Plan Commission

Agenda

Monday, September 28, 2020

COVER SHEET

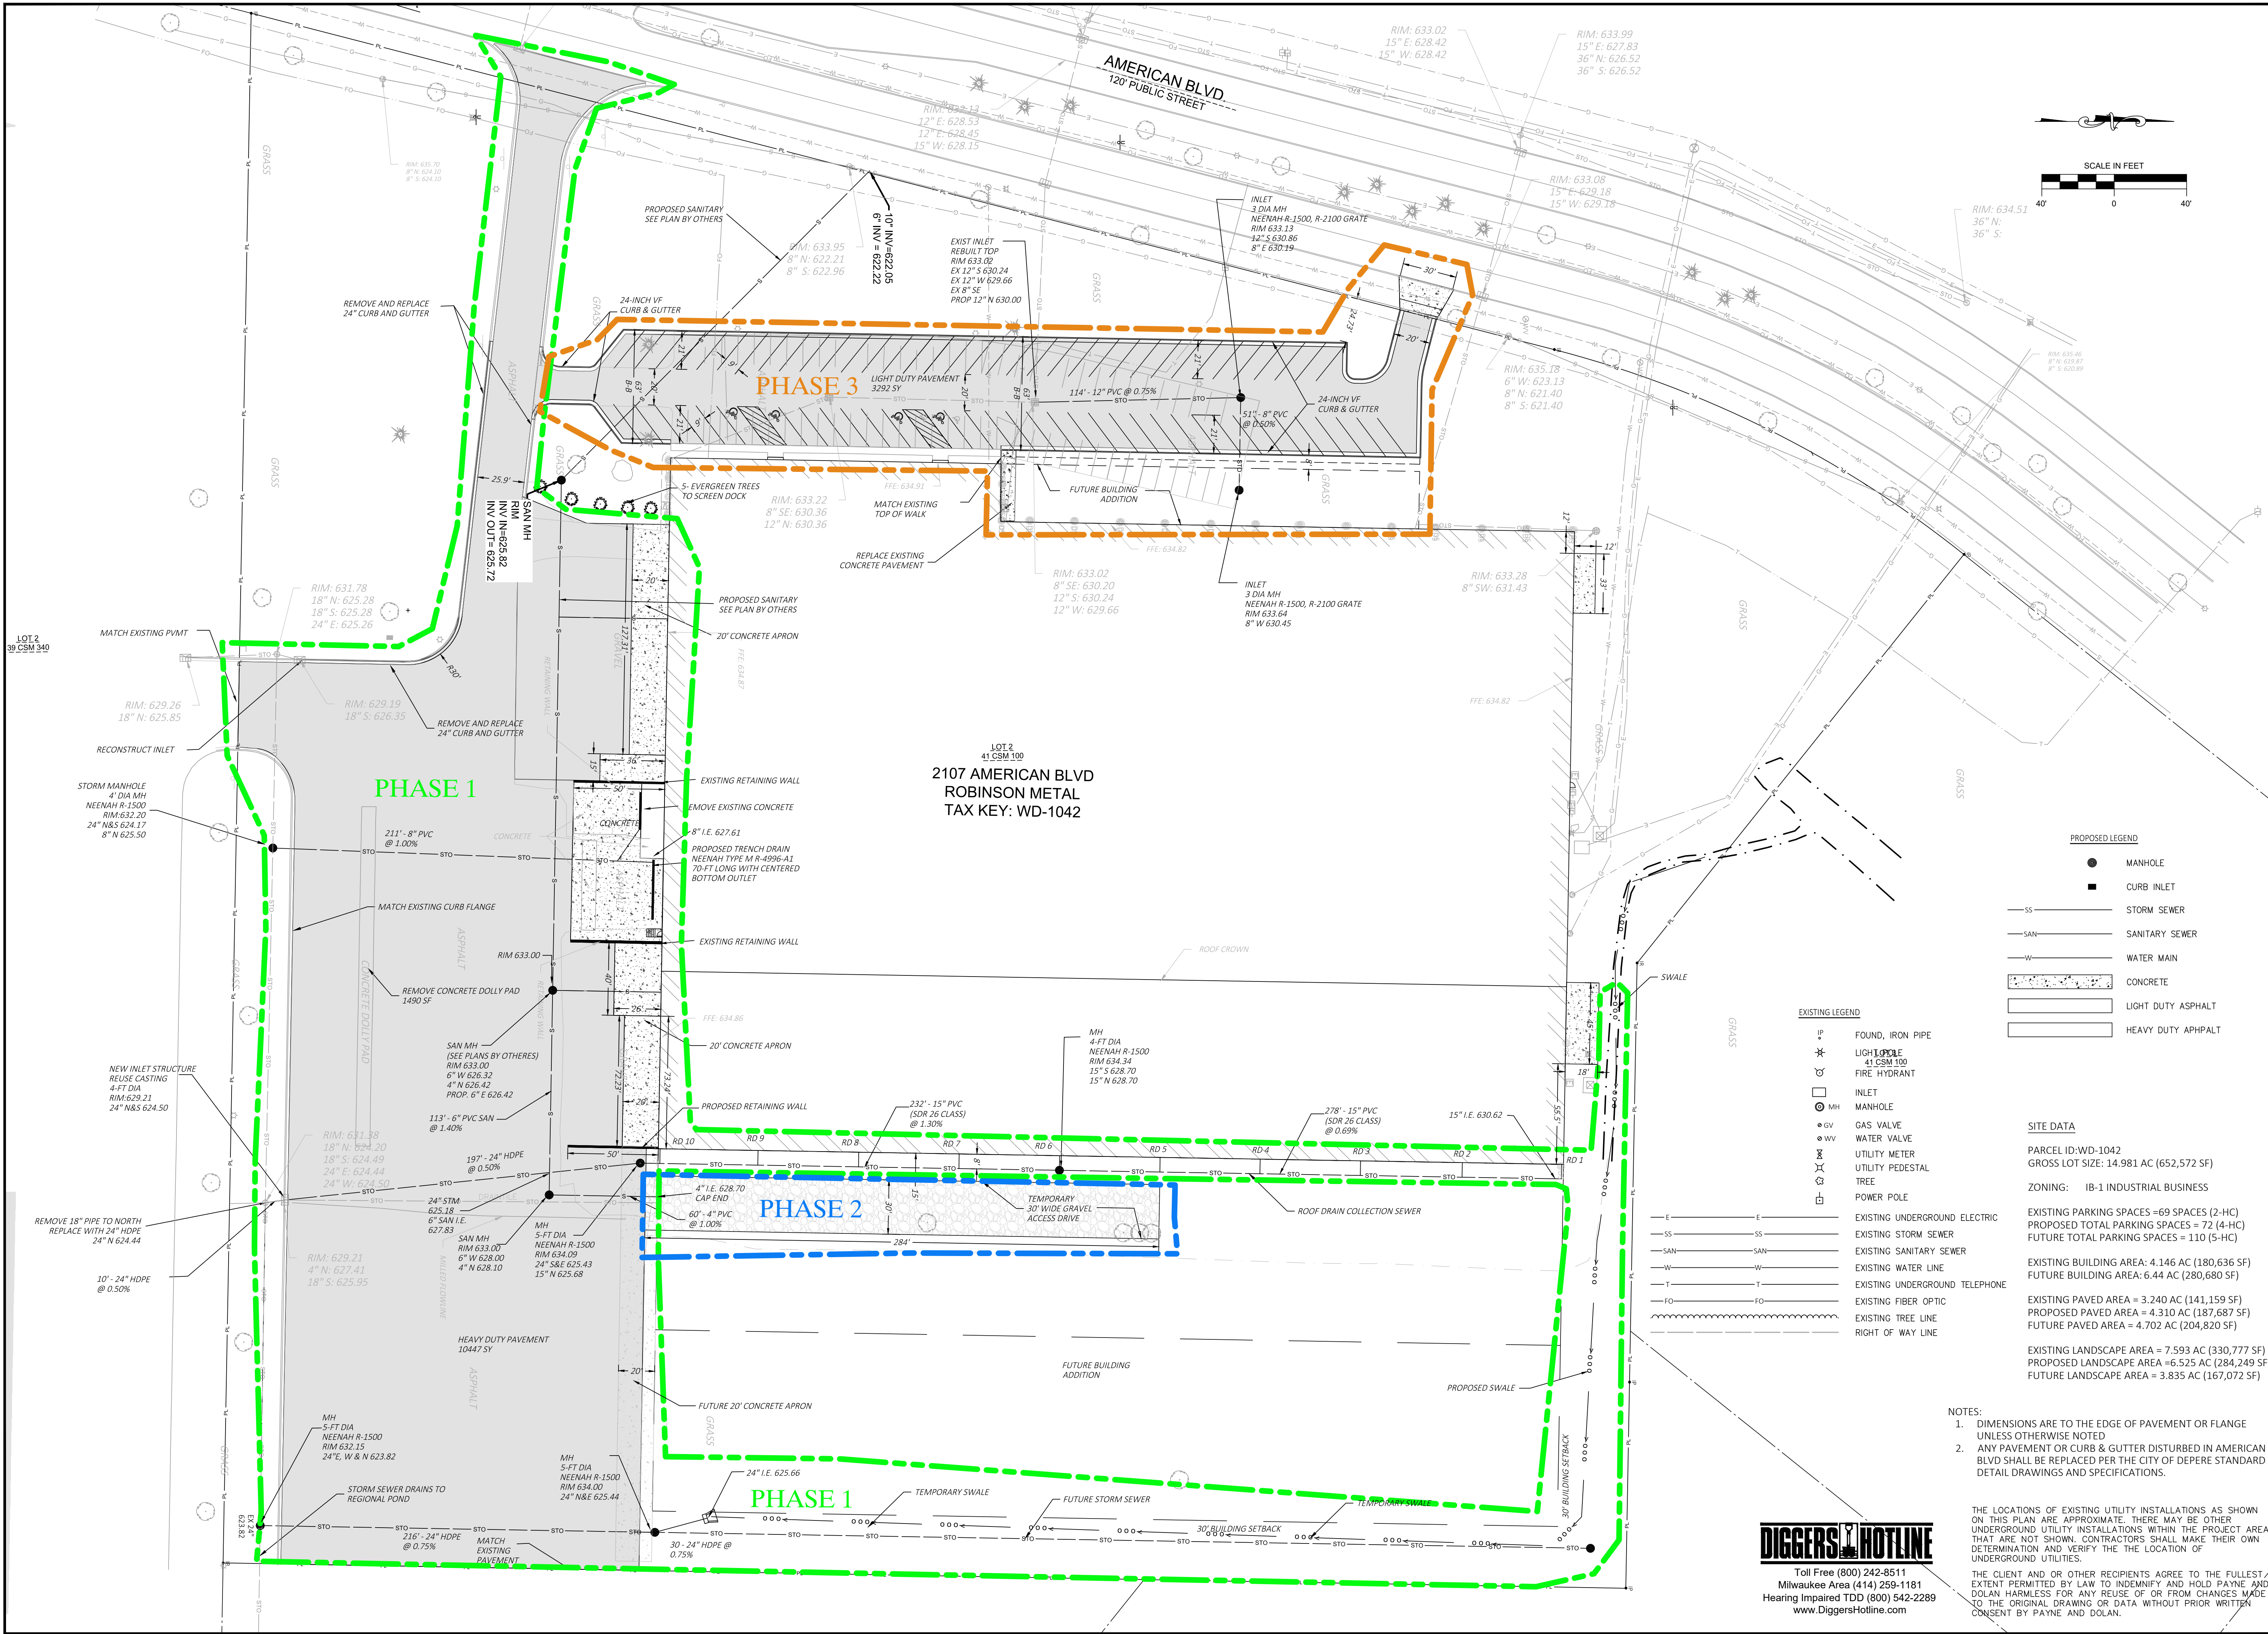
1. On Sheet C0:
 - a. Provide address for project location.
2. On Sheet C1:
 - a. Provide property line dimensions.
 - b. Identify any changes to the lighting plans.

SITE PLAN

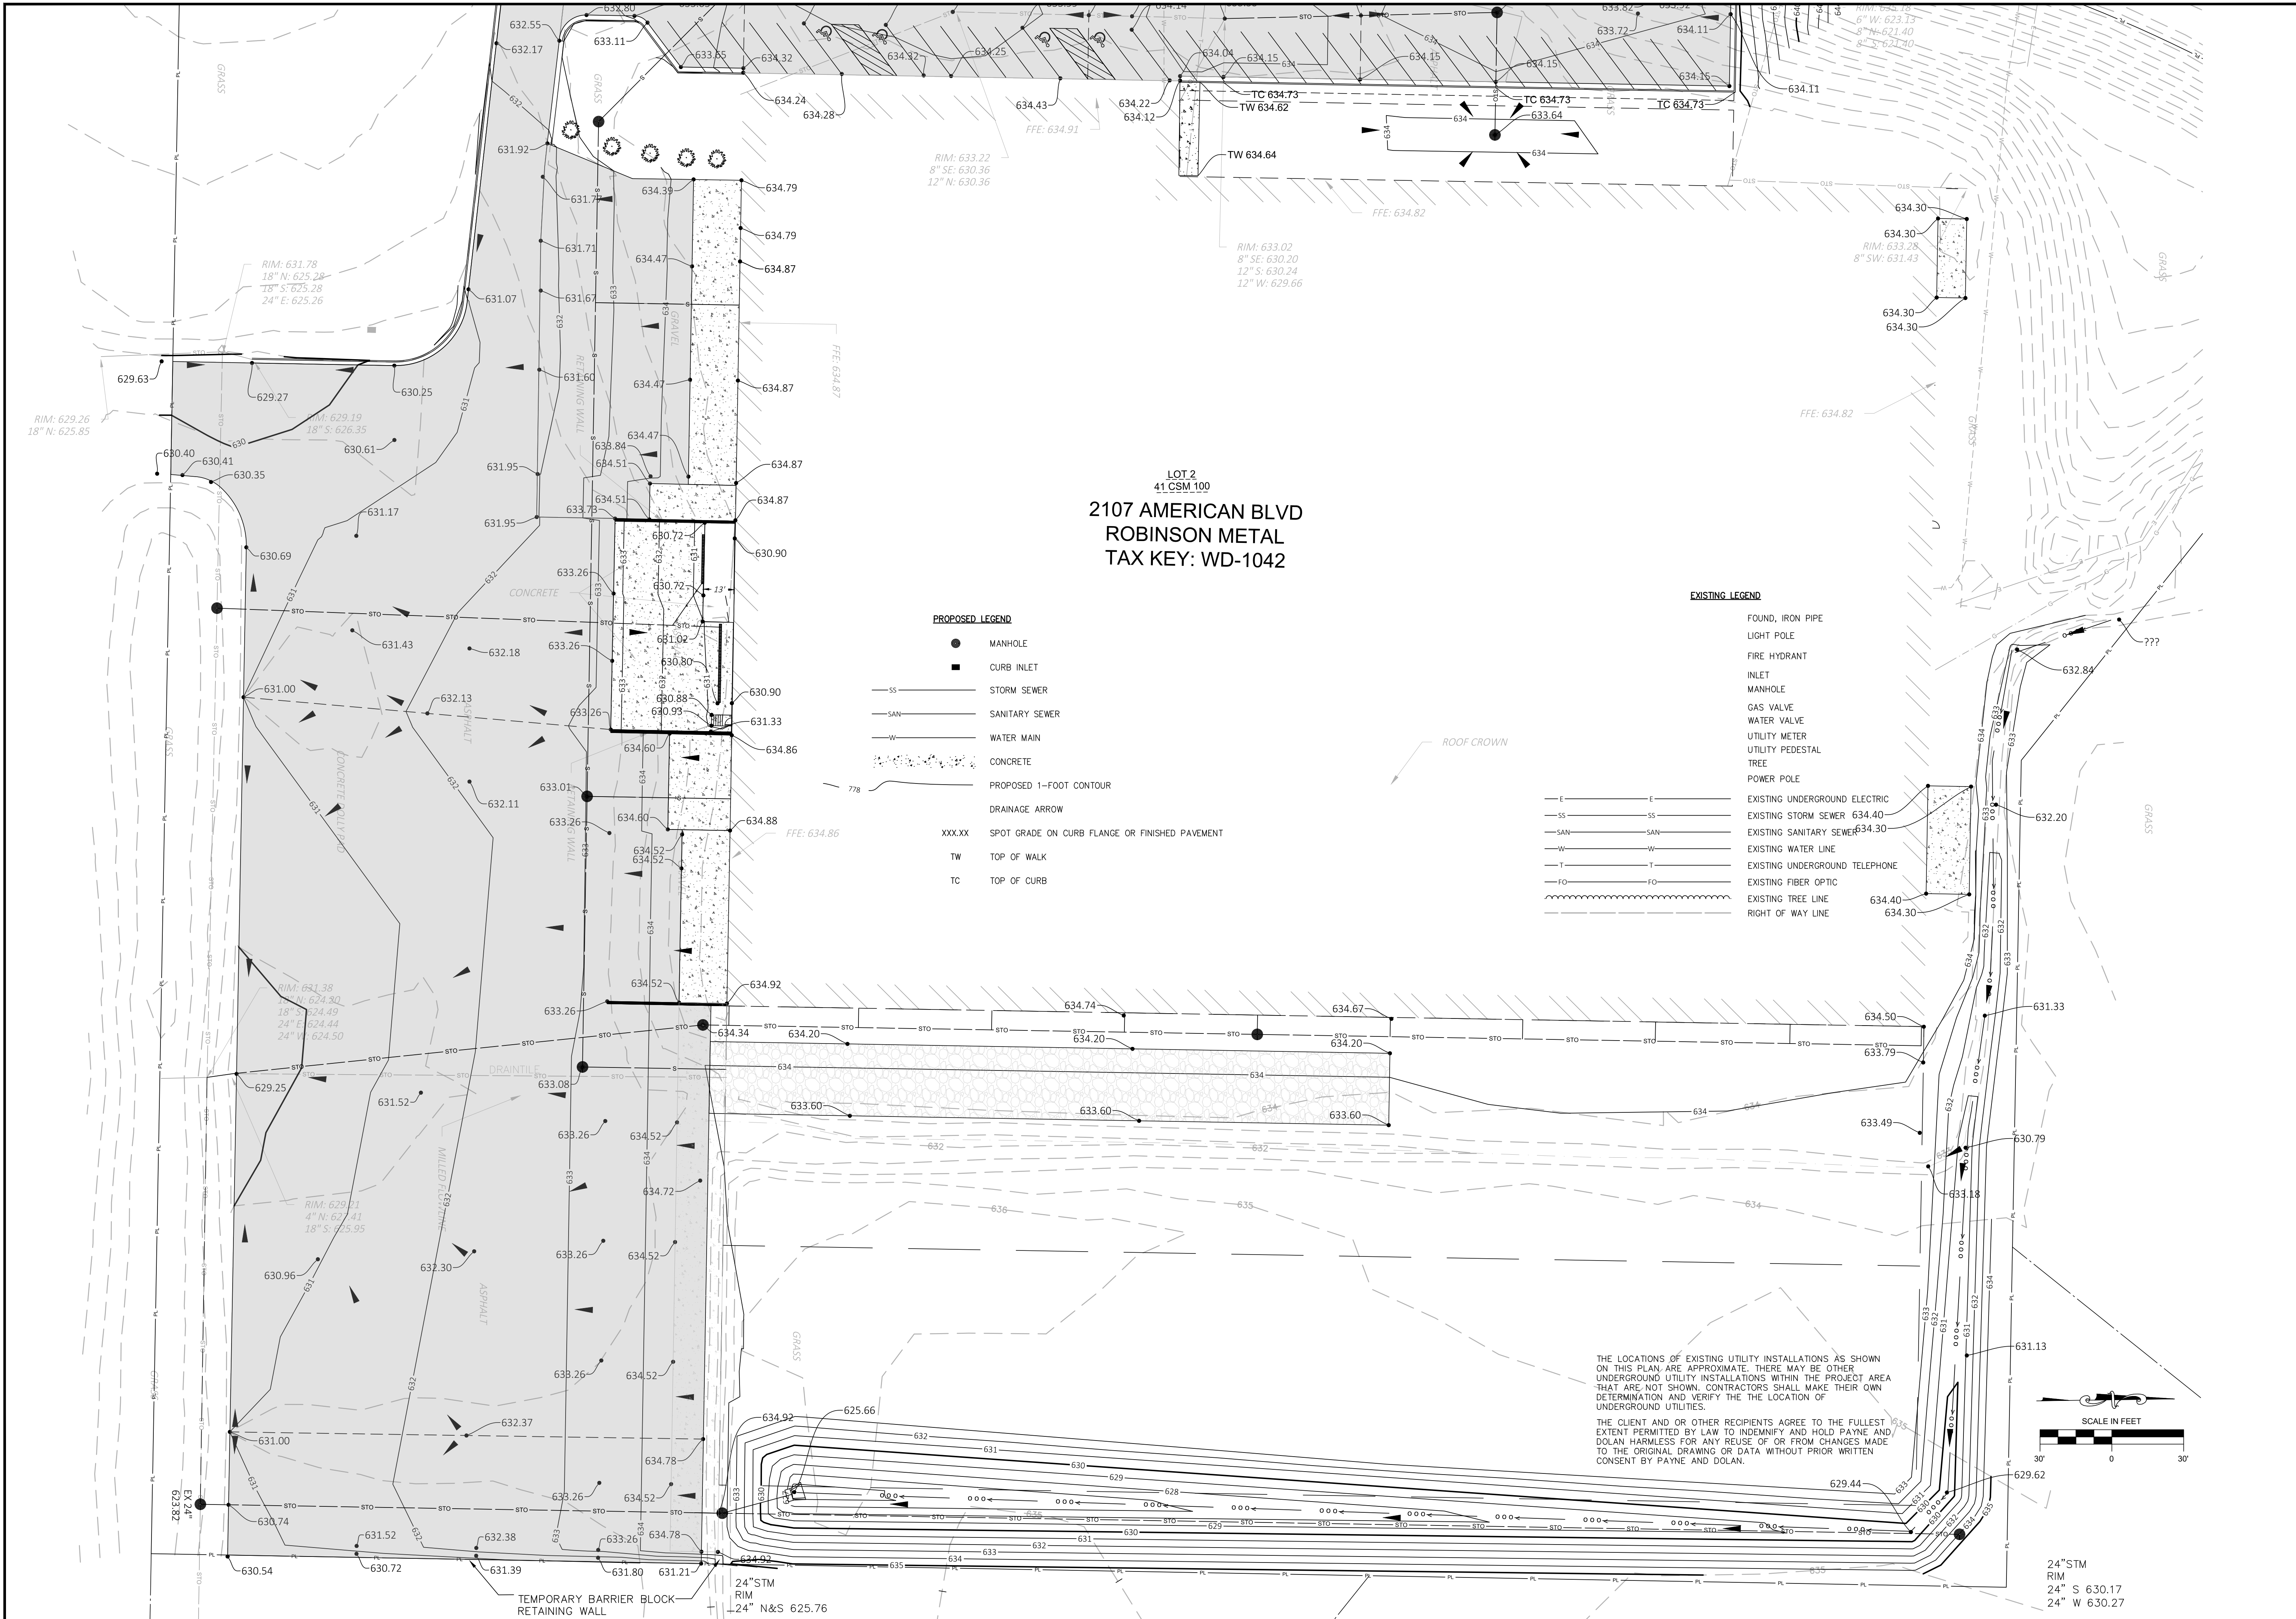
3. On Sheet C2:
 - a. The existing legend is missing half of its symbology.
 - b. The proposed legend is missing symbology for drainage arrow.
 - c. Update 633 contour to the east of the building.

- d. Provide elevation of the swale to the north of the building. Currently, there is a grade called out as "???"
4. On Sheet C3:
 - a. Provide elevation of the swale to the north of the building. Currently, there is a grade called out as "???"

- 5. Clarify the Three Phases in the site plan. Potentially with timelines as a site plan will expire after one year.
- 6. Add the coniferous trees being used to screen the building (shown on sheet C2) to the landscape plan.

LIGHT DUTY HMA PAVEMENT SECTION

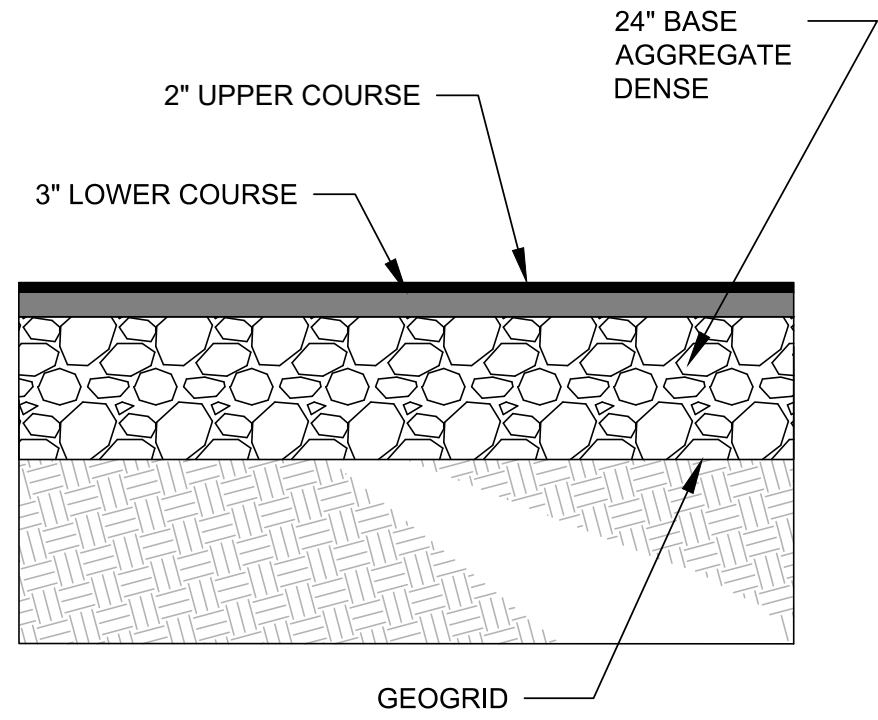
- g. Specify Type D inlet protection in the proposed legend.
6. On Sheet C5:
 - a. Correct typo - "LIGHT" DUTY HMA PAVEMENT SECTION.
5. On Sheet C-6:
